**Request for Additional Information No. 115, Supplement 1**

**U. S. EPR Standard Design Certification**

**SRP Section: 14.03.02 - Structural and Systems Engineering - Inspections, Tests,  
Analyses, and Acceptance Criteria**

**Application Section: FSAR Ch 14**

**Table 2.1.3-1—Nuclear Auxiliary Building Inspections, Tests, Analyses, and Acceptance Criteria**

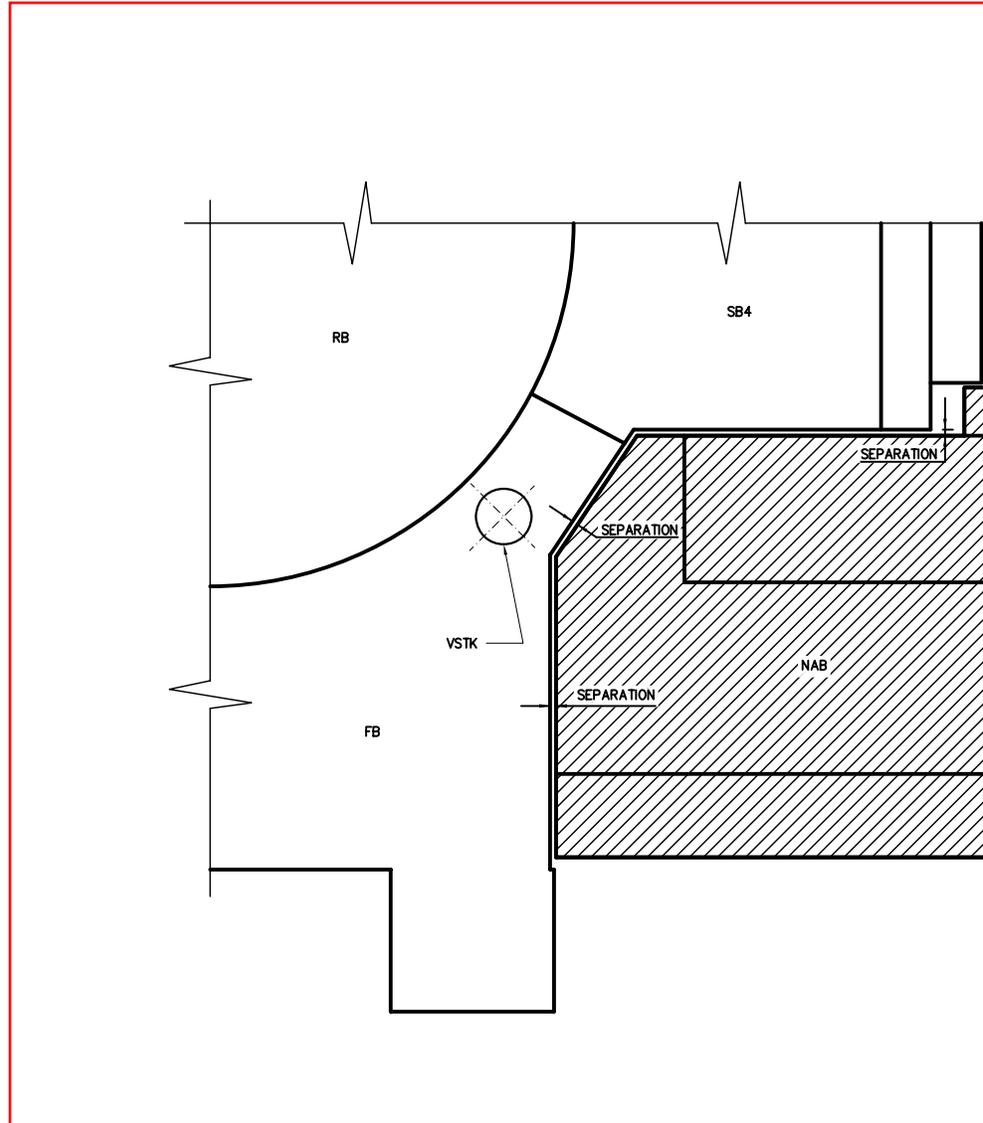
SRP 14.3 App. A IV.4.B states that Acceptance Criteria should be objective and unambiguous. The Commitment Wording for Item 3.1 states, in part, that..."as shown on Figure 2.1.3-1, seismic separations are provided between the NAB and surrounding buildings". The AC for Item 3.1 states, in part, that..."The as-built NAB is separated from surrounding buildings as shown on Figure 2.1.3-1". Why doesn't the Item 3.1 ITAAC Commitment Wording state what minimum dimensions are required to permit seismic separation to exist between NAB and surrounding buildings, and the AC require that minimum dimensions be met to achieve desired seismic separation?

- U.S. EPR FSAR Tier 1, Section 2.1.3, Item 3.1 and Table 2.1.3-1, Item 3.1 will be revised to clarify that the separation distance is provided to preclude interaction between the buildings. U.S. EPR FSAR Tier 1, Table 2.1.3-1, ITAAC Item 3.1 will be revised to require a site-specific analysis to be performed and the site building layout to be verified to meet the minimum required separation distance.

- U.S. EPR FSAR Tier 1, Figure 2.1.3-1 will be revised to remove the identification of a separation distance between the NAB and RWB.
- U.S. EPR FSAR Tier 1, Section 2.1.4, Item 3.1 and Table 2.1.4-1, Item 3.1 will be revised to provide the minimum seismic separation distance.

3.1 Seismic separations are provided between the NAB and ~~surrounding buildings~~ the NI common basemat structures as shown on Figure 2.1.3-1 with sufficient clearance to preclude seismic interaction between the NAB and NI common basemat structures.

Table 2.1.4-1—Radioactive Waste Building Inspections, Tests, Analyses, and Acceptance Criteria

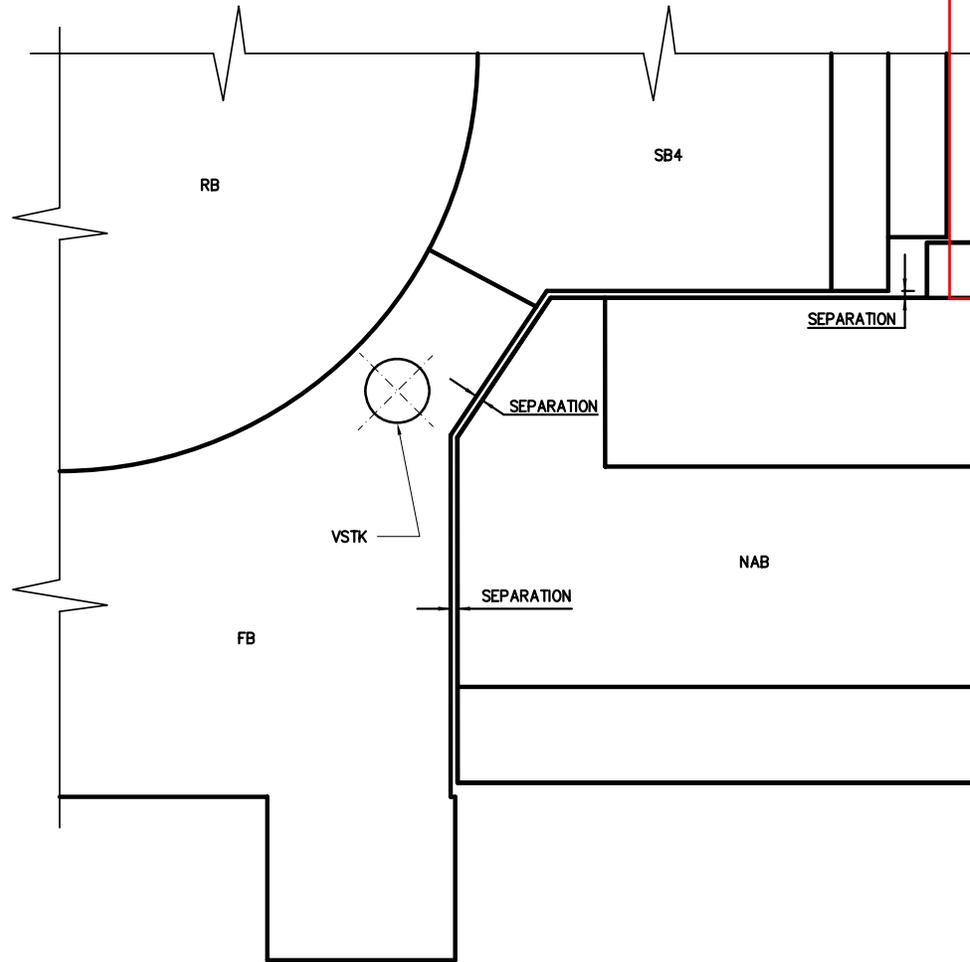
ITAAC Item 3.2 in Table 2.1.4-1

- U.S. EPR FSAR Tier 1, Figure 2.1.4-1 will be revised to remove the identification of a separation distance between the NAB and RWB.
- U.S. EPR FSAR Tier 1, Figure 2.1.4-1 will be revised to add a separation distance between the RWB and 3/4EPGB.

3.1 ~~Seismic~~ Separations ~~are~~ is provided between the RWB and ~~surrounding buildings~~ 3/4EPGB as shown on Figure 2.1.4-1 with sufficient distance to preclude interaction between the RWB and 3/4EPGB.
